City of Biddeford
Planning Board
July 21, 2021 6:00 PM City Hall
Council Chambers, & Zoom:
Jul 21, 2021 06:00 PM Eastern Time (US and Canada)
Topic: Planning Board

5. **UNFINISHED BUSINESS**
6. **NEW BUSINESS**
 - 6.A. 2021.17 - Public Hearing and Preliminary Subdivision/Site Plan Review for a proposed Contract Zone for Adams Point, LP and Southern Maine Affordable Housing at 69 Adam's Street (Tax Map 38, Lot 296) to allow for 39 units of multi-family housing in a 5-storey, 60 foot tall building (plus additional height for utility and elevator structures at a reduced parking provision 0.75 parking spaces per unit.
[2021.17 Board Report - Adams Point Prelim Plan.pdf](#)
[Site Plan Review Application & Supporting Materials_06-14-2021.pdf](#)
[Tansley Transmittal 06-14-2021.pdf](#)
[Adams Point Drawings Site Plan Review 06-14-2021.pdf](#)
[2021.10 HPC 69 Adams St COA.pdf](#)
[2021-06-25_69 Adams Street - Engineering Dept Comments.pdf](#)
[Saucier to Tansley 07-07-21.pdf](#)

Site Plan/Subdivision Preliminary Plan Review

ADAMS POINT HOUSING
69 Adams Street
Biddeford, Maine, 04005

4 TYPICAL DRIVEWAY/WALK/RETAINING WALL SECTION
CS101, C-504 SCALE: 3/8"=1'-0"

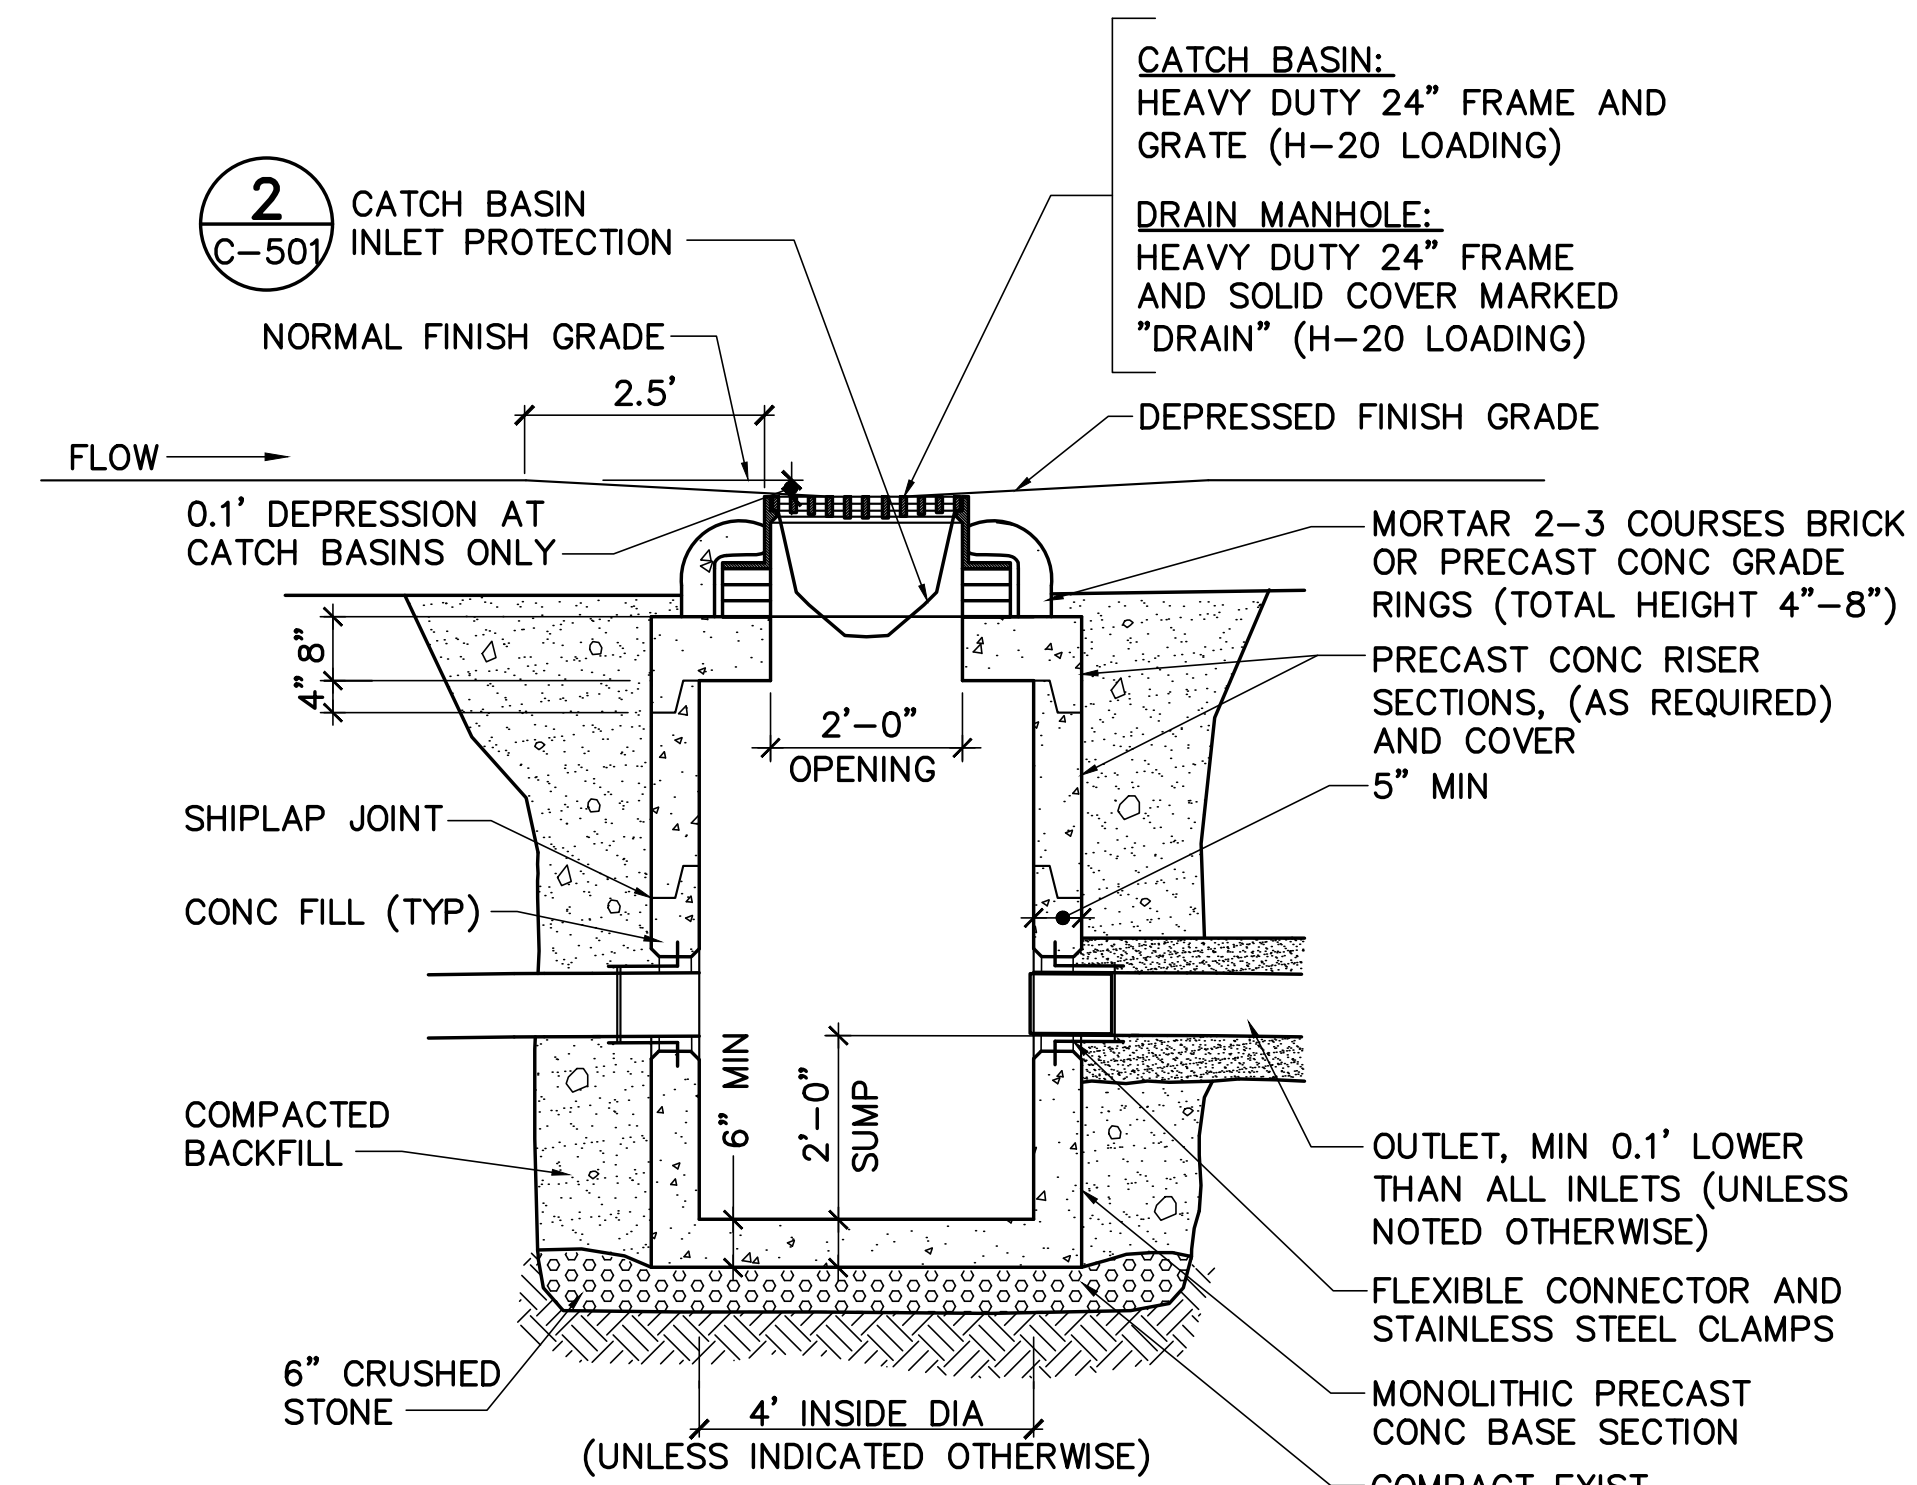
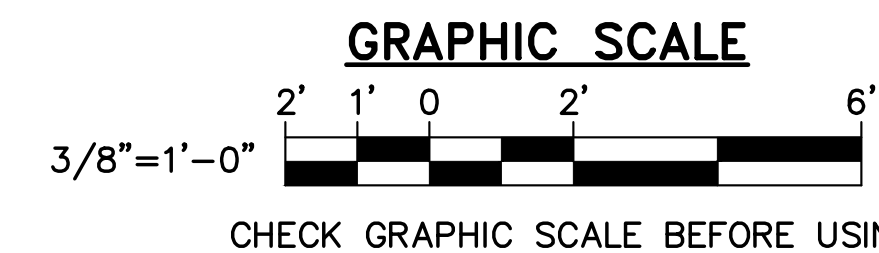
4. Sheet 11 of 19 – Site Details -1

2 POST-DEVELOPMENT WATERSHED PLAN
WS101 1"=50'

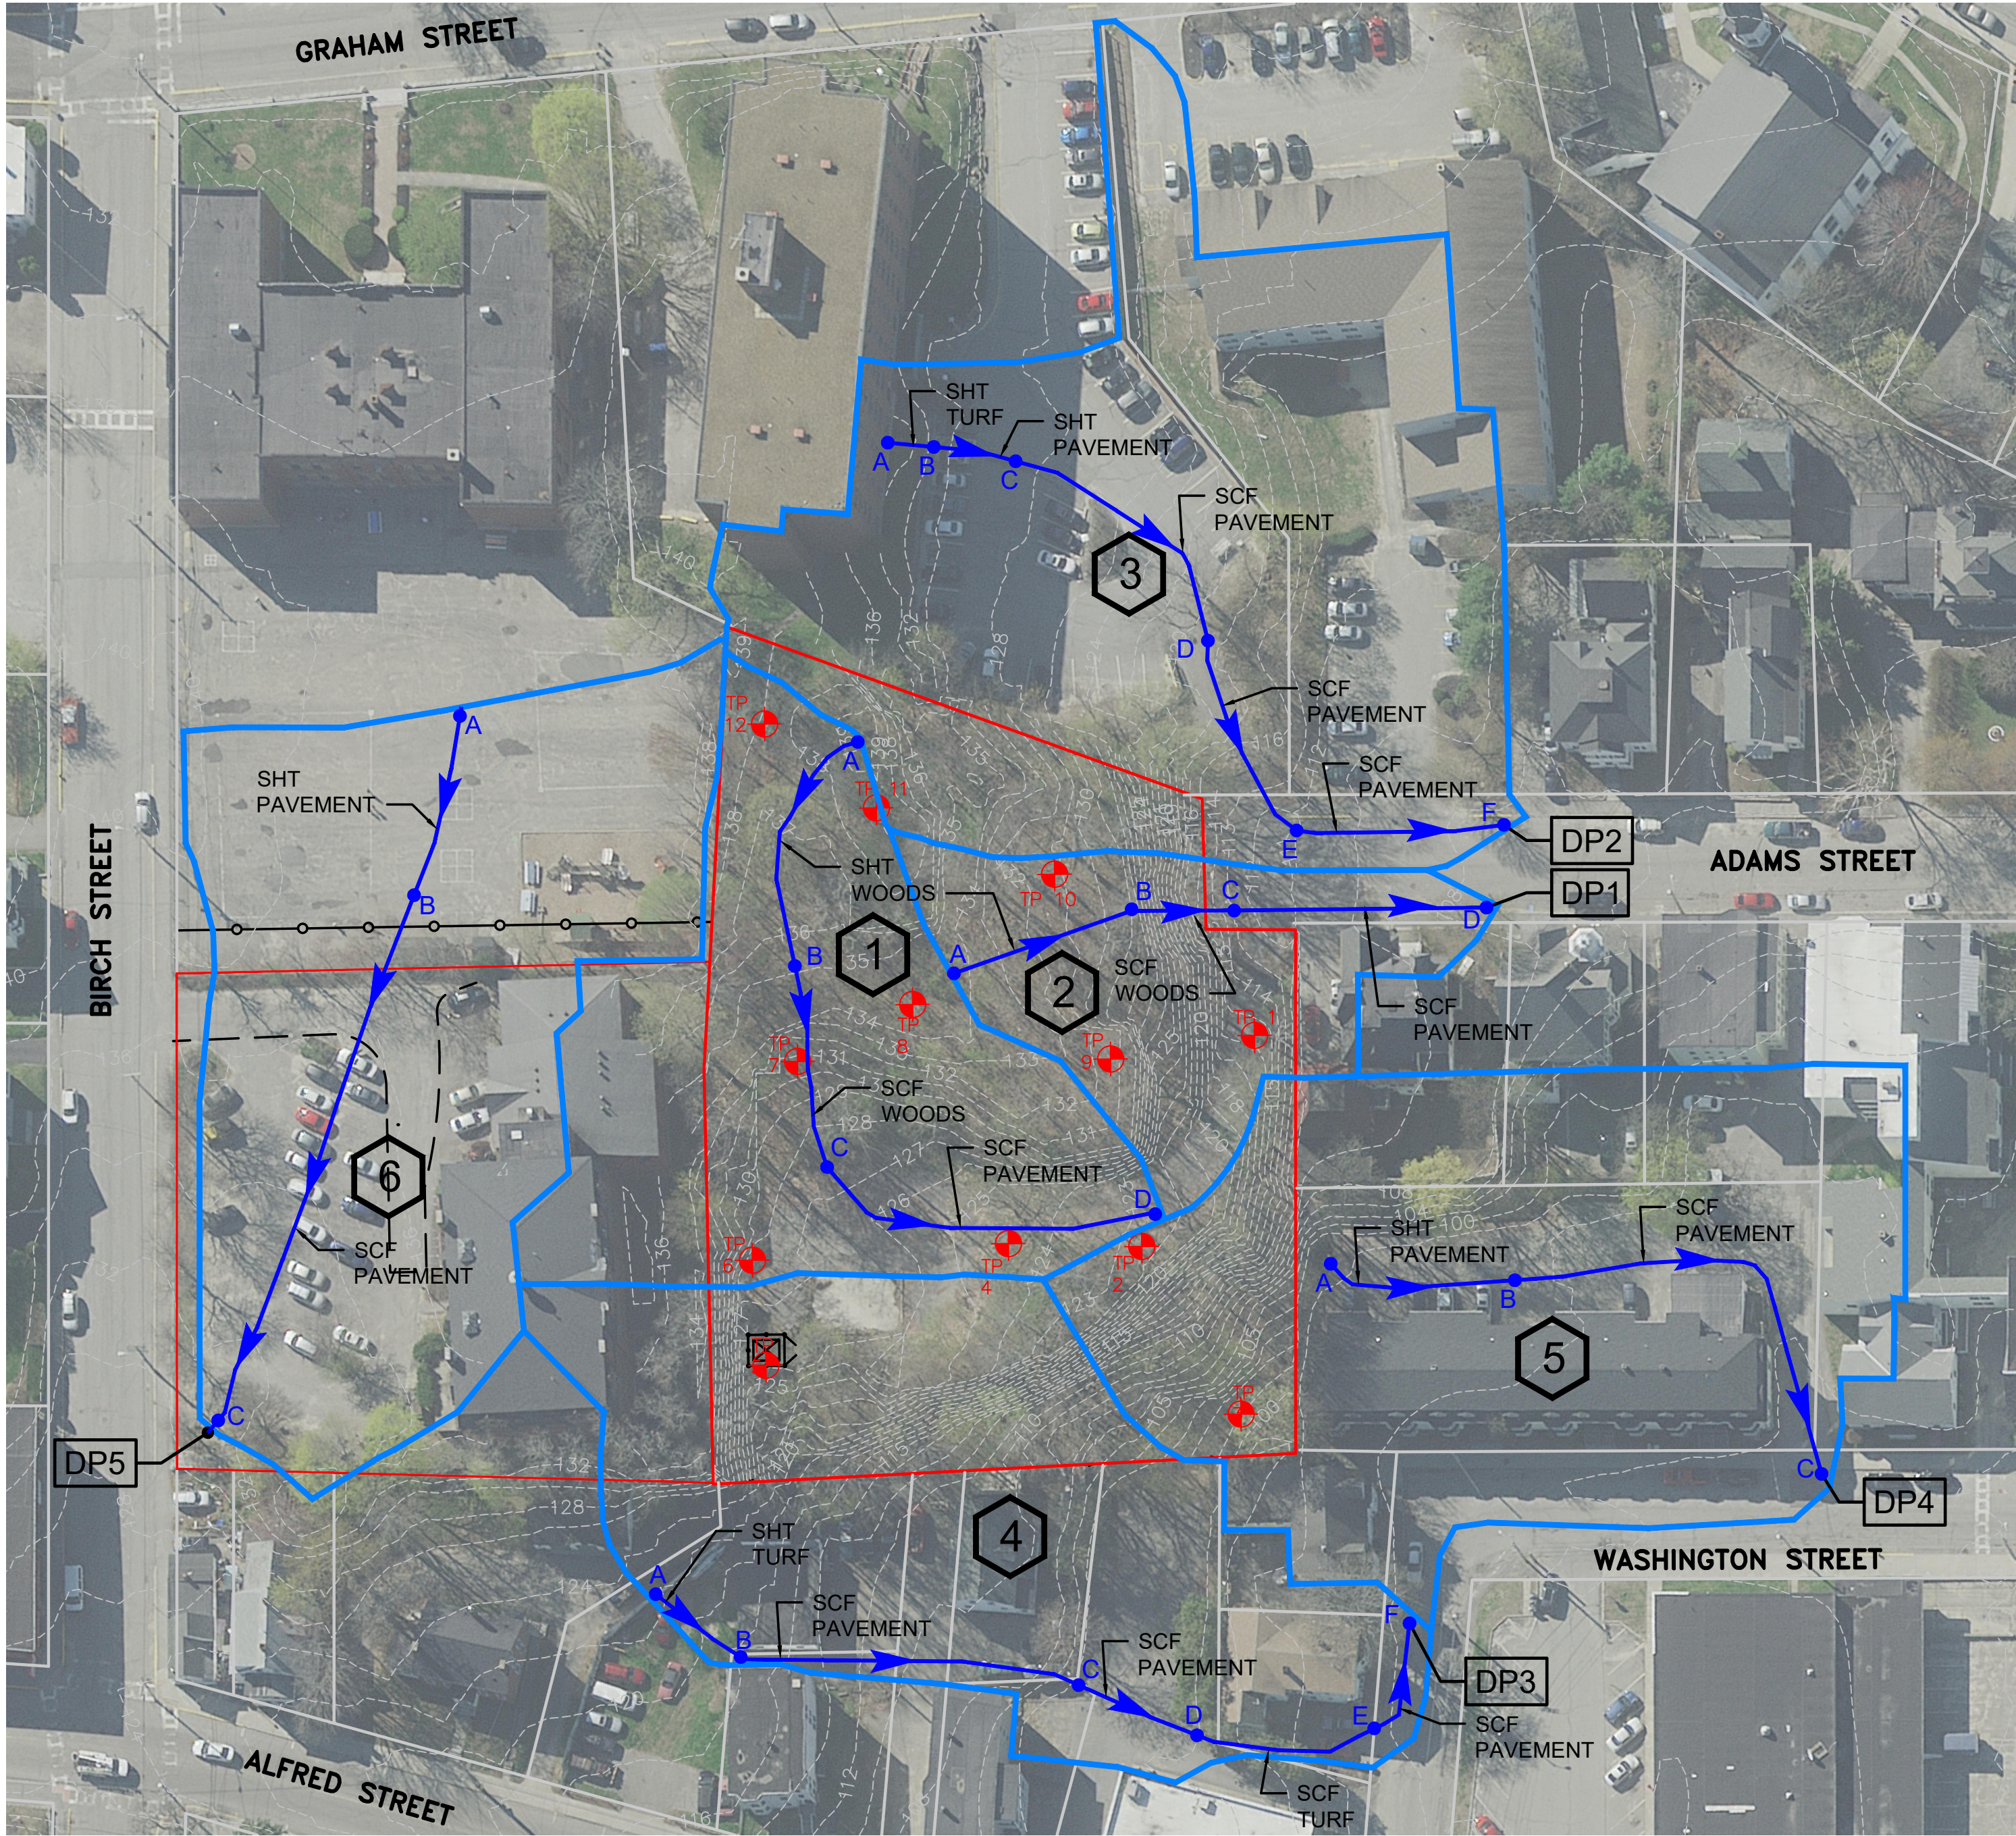
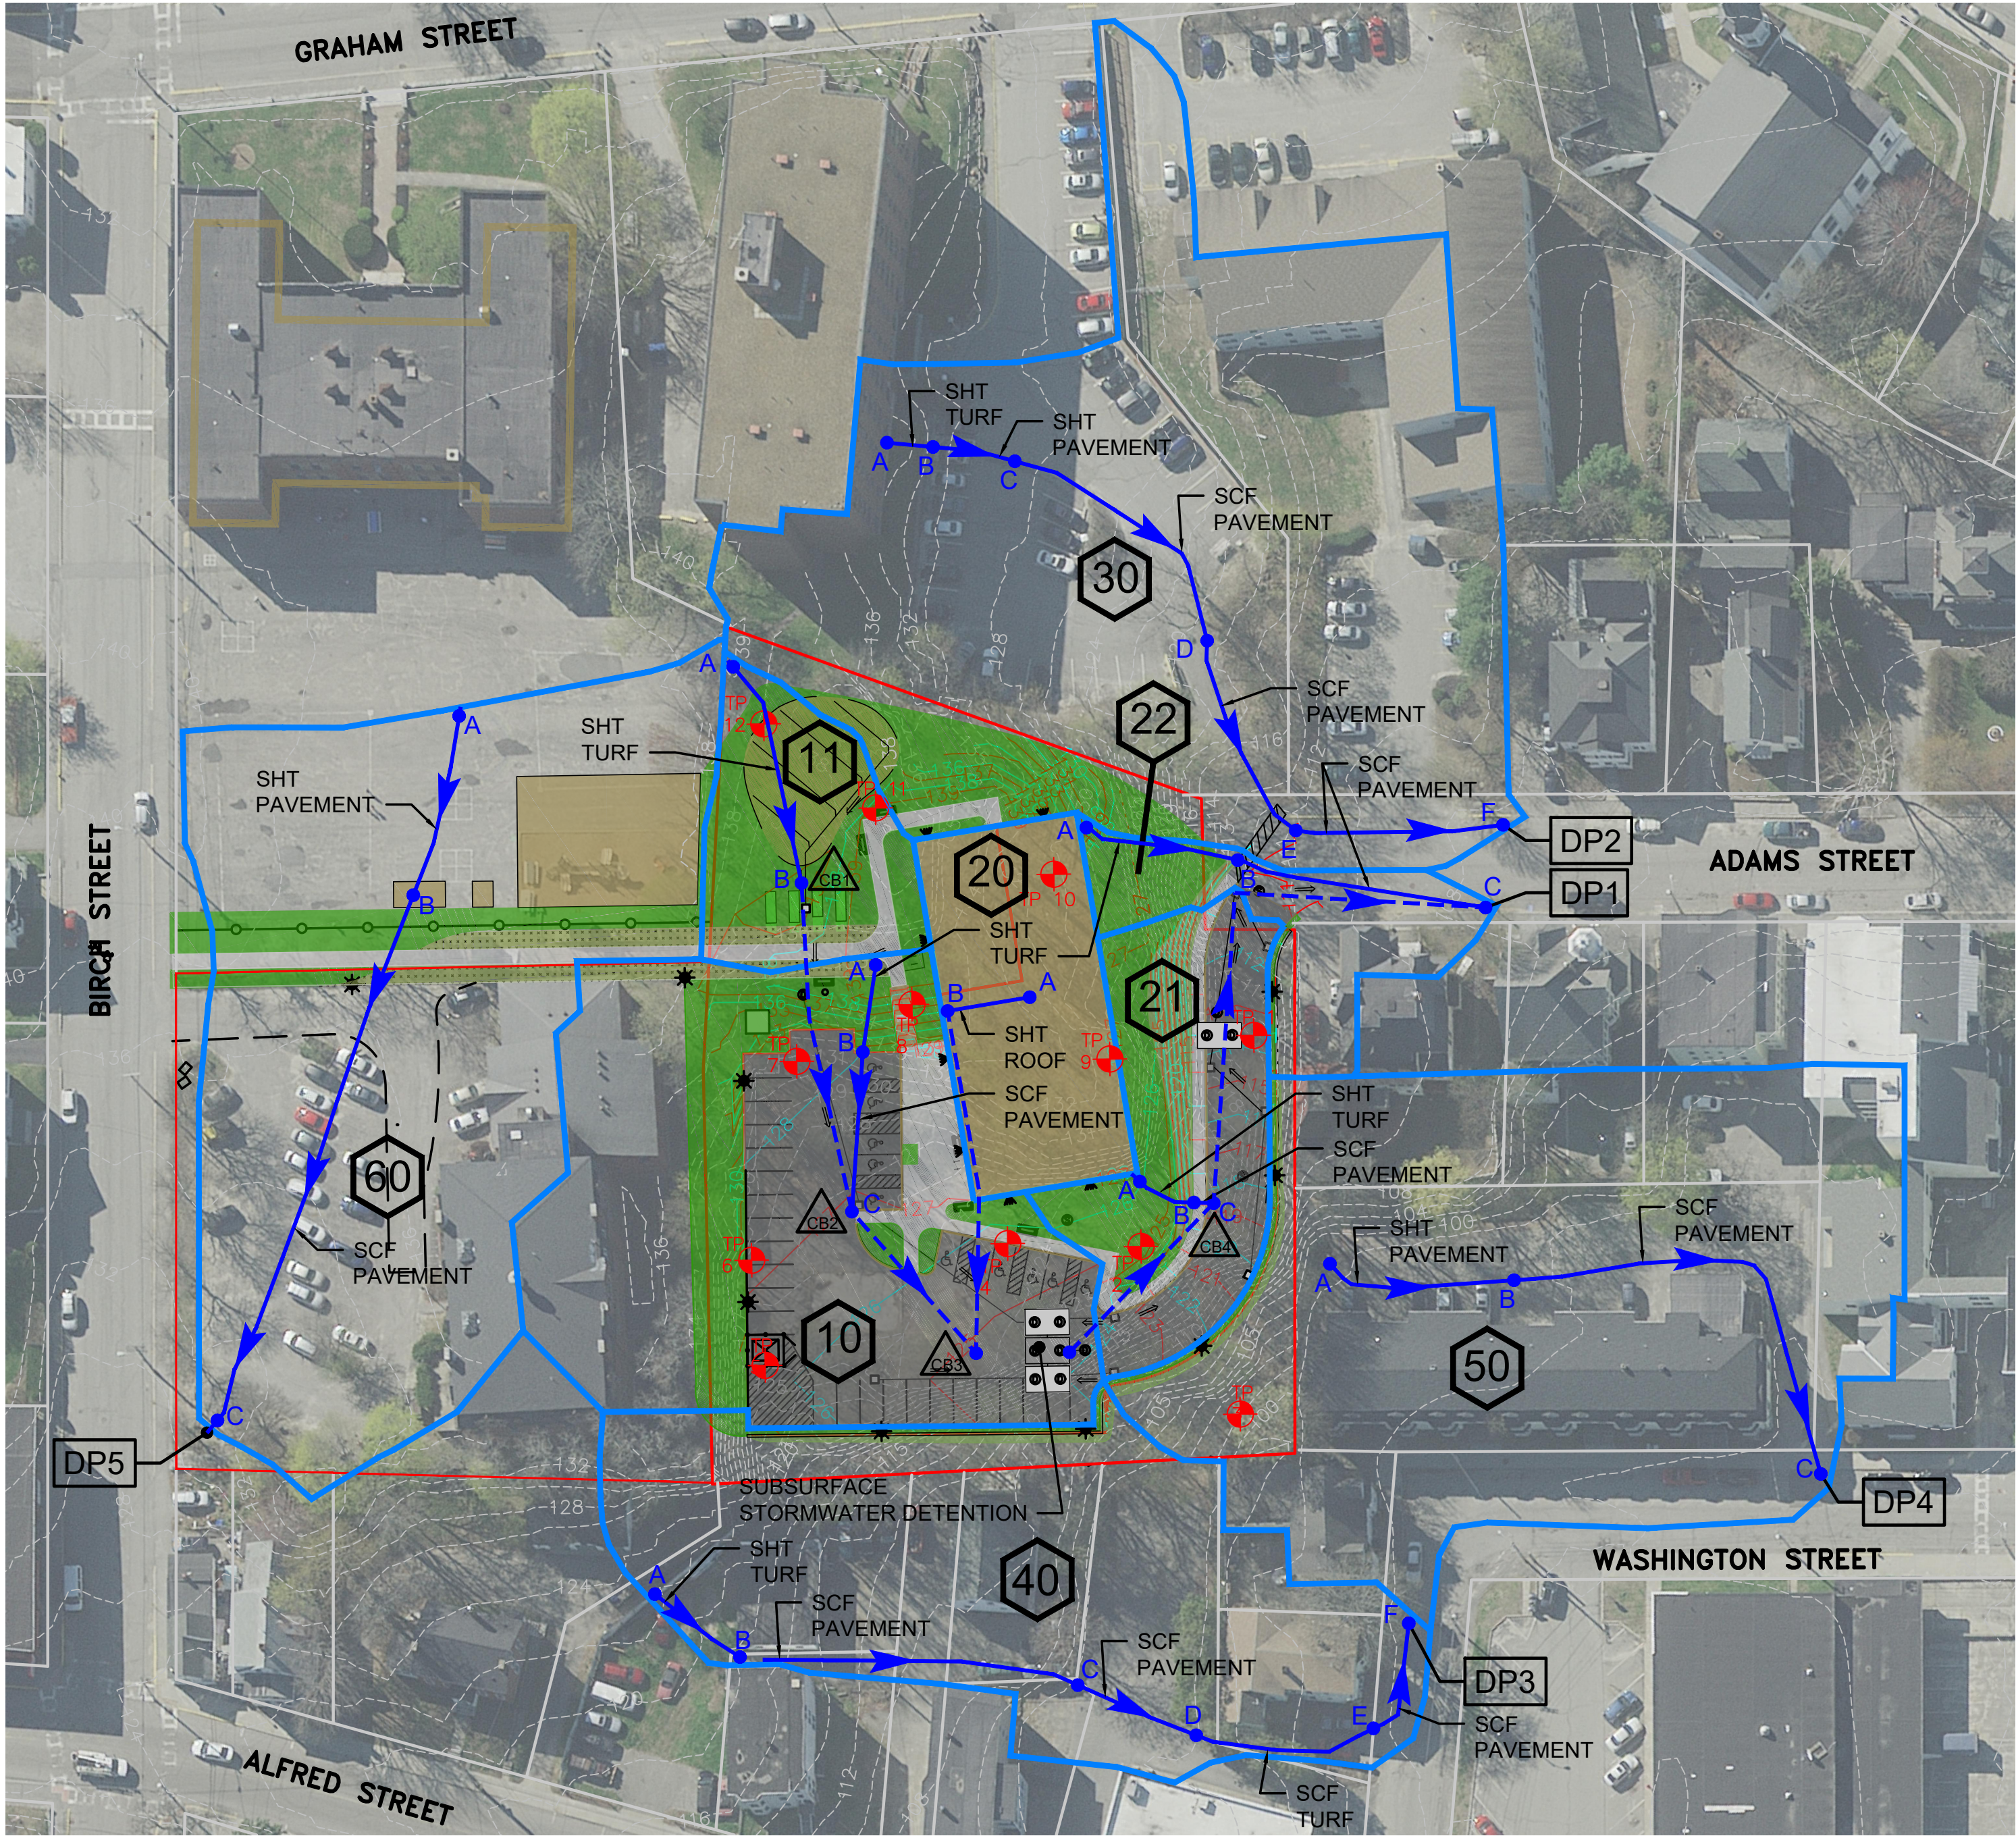
- **Sheet WS101**
 - o Watershed areas, individual land cover areas, curve numbers, and times of concentration not identified/summarized for pre- and post-development conditions
